Subject: Duke Energy Carolinas, LLC (Duke Energy)

Catawba Nuclear Station (CNS), Units 1, and 2  
CNS Docket Nos. 50-413, 50-414

Technical Specifications Revision Request to Adopt TSTF-490, Rev. 0  
"Deletion of E Bar Definition and Revision to RCS Specific Activity"

Duke  
Energy  
Fleet-Wide  
Licensing  
Amendment  
Request

Figure 3.4.16-1 (page 1 of 1)  
Reactor Coolant DOSE EQUIVALENT I-131 Specific Activity  
Limit Versus Percent of RATED THERMAL POWER

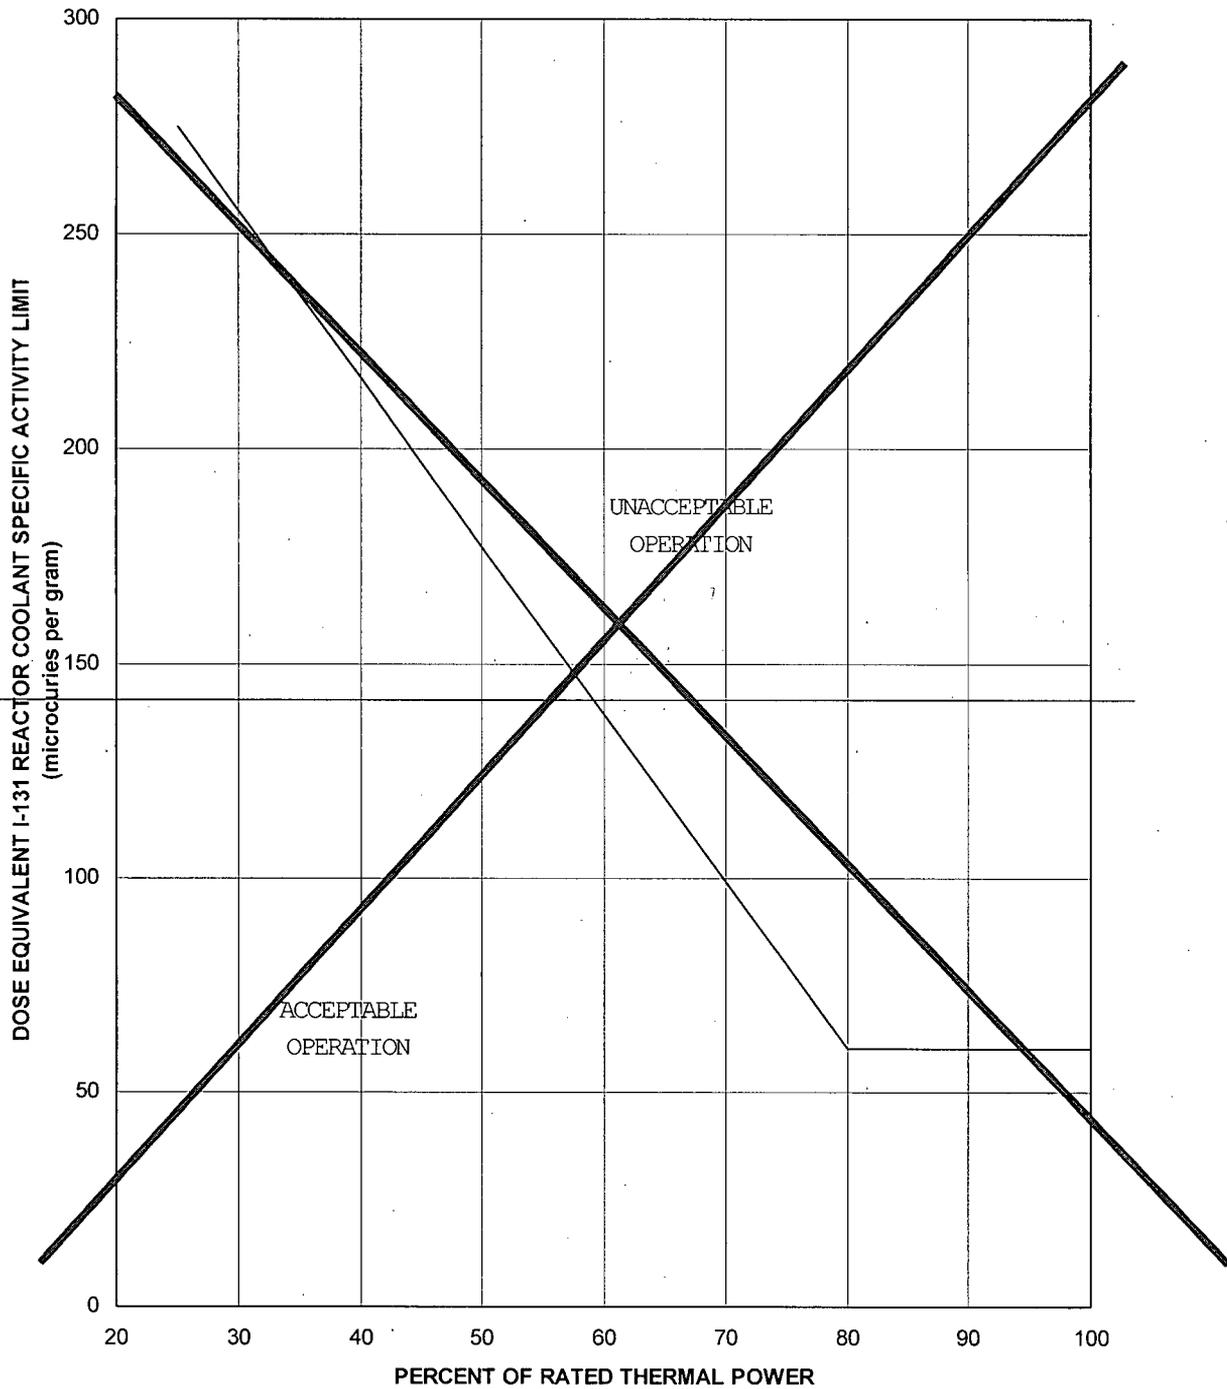
- Revise LCO 3.4.16 (CNS, MNS) and LCO 3.4.11 (ONS), "RCS Specific Activity," to delete references to gross specific activity; add limits for DOSE EQUIVALENT I-131 and DOSE EQUIVALENT XE-133; and delete Figure 3.4.16-1 (CNS, MNS) and Figure 3.4.11-1 (ONS), "Reactor Coolant DOSE EQUIVALENT I-131 Specific Activity Limit versus Percent of RATED THERMAL POWER."

- A. Condition A is modified to delete the reference to Figure 3.4.16-1 (CNS, MNS), Figure 3.4.11-1 (ONS), and define an upper limit that is applicable at all power levels.

CONDITION	REQUIRED ACTION	COMPLETION TIME
<p>C. Required Action and associated Completion Time of Condition A not or B not met.</p> <p><u>OR</u></p> <p>DOSE EQUIVALENT I-131 &gt; 60 <math>\mu\text{Ci/gm}</math> in the unacceptable region of Figure 3.4.16-1.</p>	<p>C.1 Be in MODE 3<sub>2</sub> with <math>T_{\text{avg}} &lt; 500^\circ\text{F}</math>.</p> <p><u>AND</u></p>	6 hours
	<p>C.2 Be in MODE 5.</p>	<u>36 hours</u>

Figure 3.4.16-1 (page 1 of 1)  
Reactor Coolant DOSE EQUIVALENT I-131 Specific Activity  
Limit Versus Percent of RATED THERMAL POWER

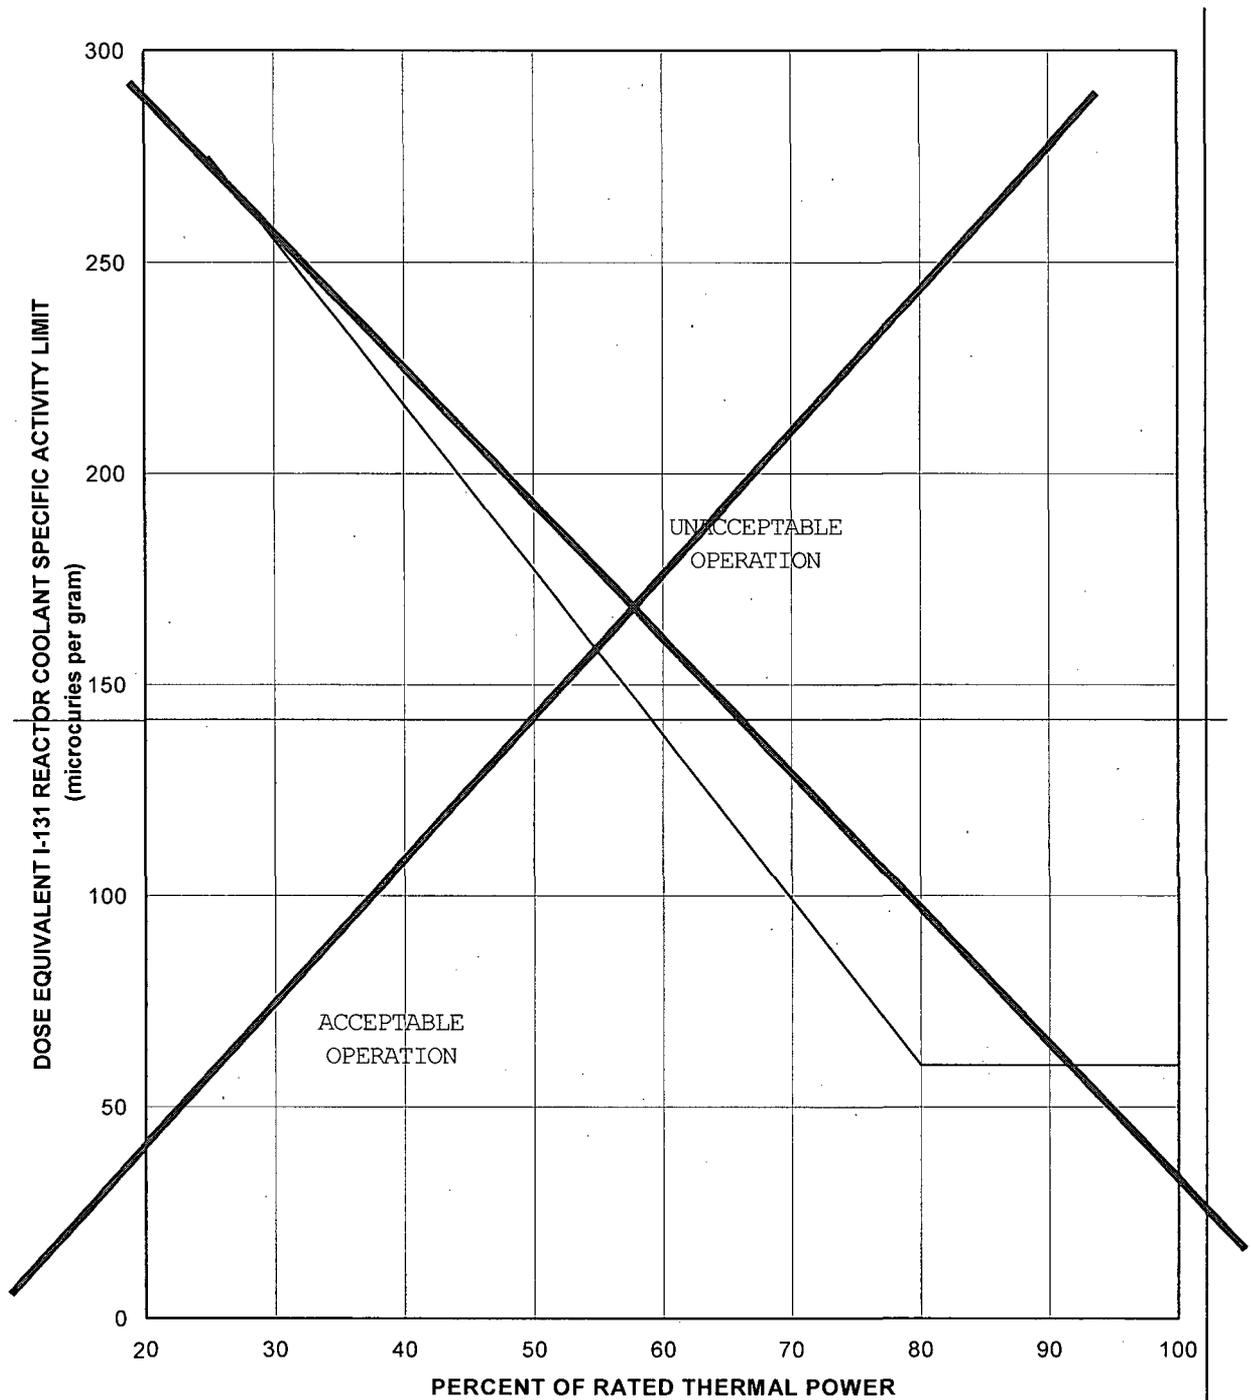
CONDITION	REQUIRED ACTION	COMPLETION TIME
<p>C. Required Action and associated Completion Time of Condition A <u>or</u> B <u>not met.</u></p> <p><u>OR</u></p> <p>DOSE EQUIVALENT I-131 in the unacceptable region of Figure 3.4.16-1. <u>&gt; 60 μCi/gm.</u></p>	<p>C.1 Be in MODE 3<sub>2</sub> with <math>T_{avg} &lt; 500^{\circ}F.</math></p> <p>C.2 <u>Be in MODE 5.</u></p>	<p>6 hours</p> <p><u>36 hours</u></p>

Figure 3.4.11-1 (page 1 of 1)  
Reactor-Coolant DOSE EQUIVALENT I-131 Specific Activity Limit  
Versus Percent of RATED THERMAL POWER With Reactor-Coolant  
Specific Activity > 1.0 µCi/gm DOSE EQUIVALENT I-131

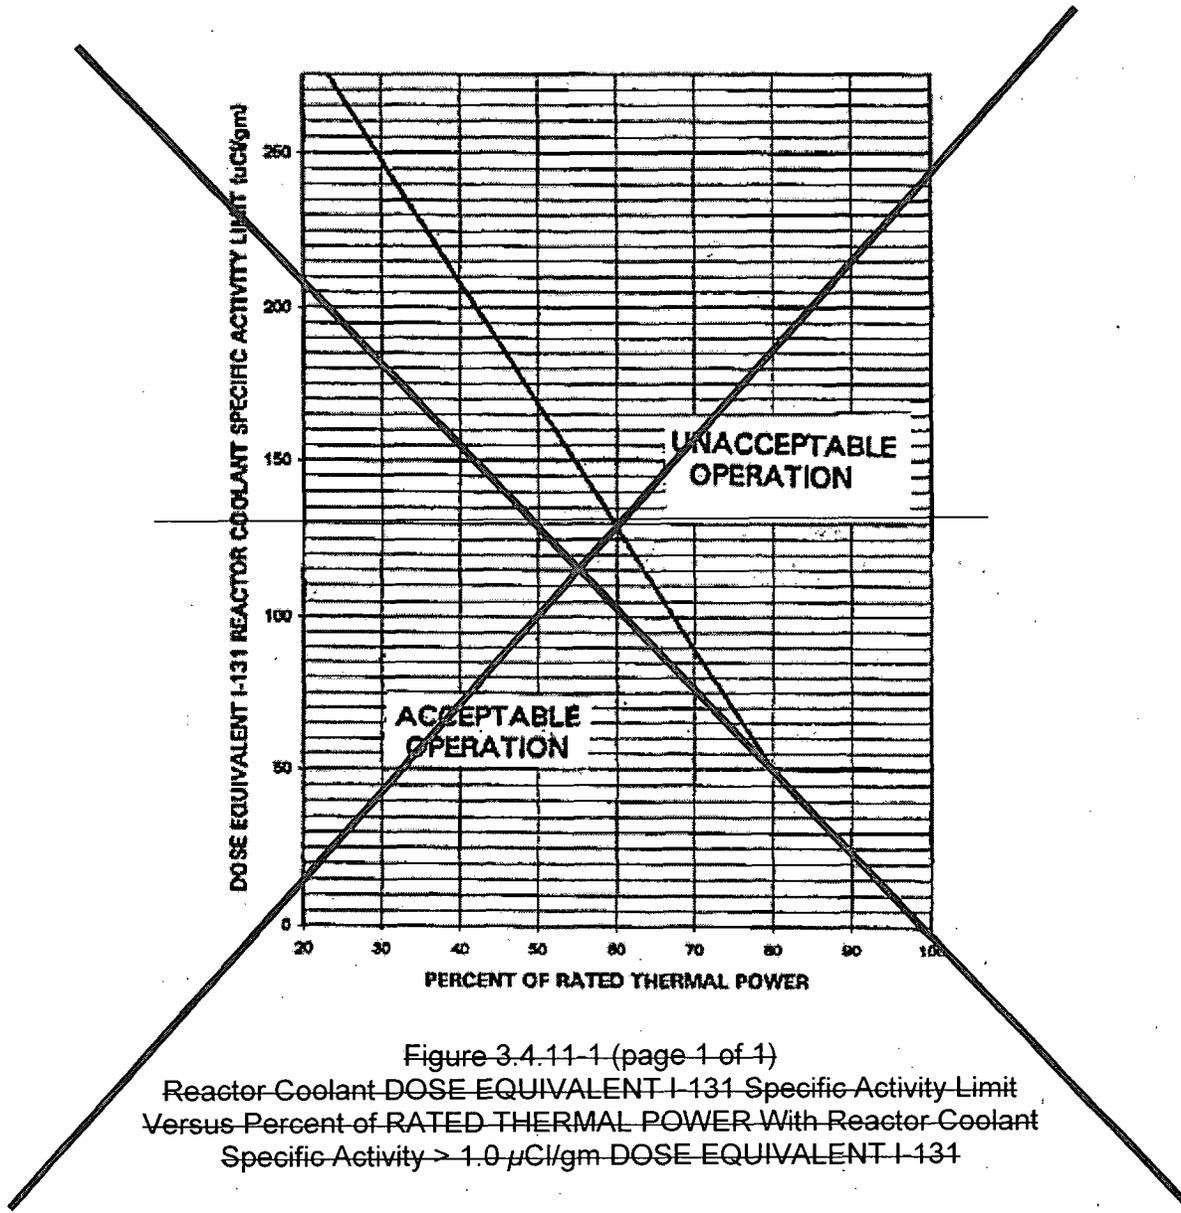
CONDITION	REQUIRED ACTION	COMPLETION TIME
<del>DOSE EQUIVALENT I-131 in unacceptable region of Figure 3.4.11- 4.</del>

CONDITION	REQUIRED ACTION	COMPLETION TIME
<p><u>C. Required Action and associated Completion Time of Condition A or B not met.</u></p> <p><u>OR</u></p> <p><u>DOSE EQUIVALENT I-131 in unacceptable region of Figure 3.4.11-1, &gt; 50 <math>\mu\text{Ci/gm}</math>.</u></p> <p><u>C. Gross specific activity of the coolant not within limit.</u></p>	<p><u>C.1 Be in MODE 3</u></p> <p><u>AND</u></p> <p><u>C.2 Be in MODE 5</u></p> <p><u>C.1 Be in MODE 3 with RCS Average Temperature &lt; 500°F.</u></p>	<p>12 hours</p> <p><u>36 hours</u></p>
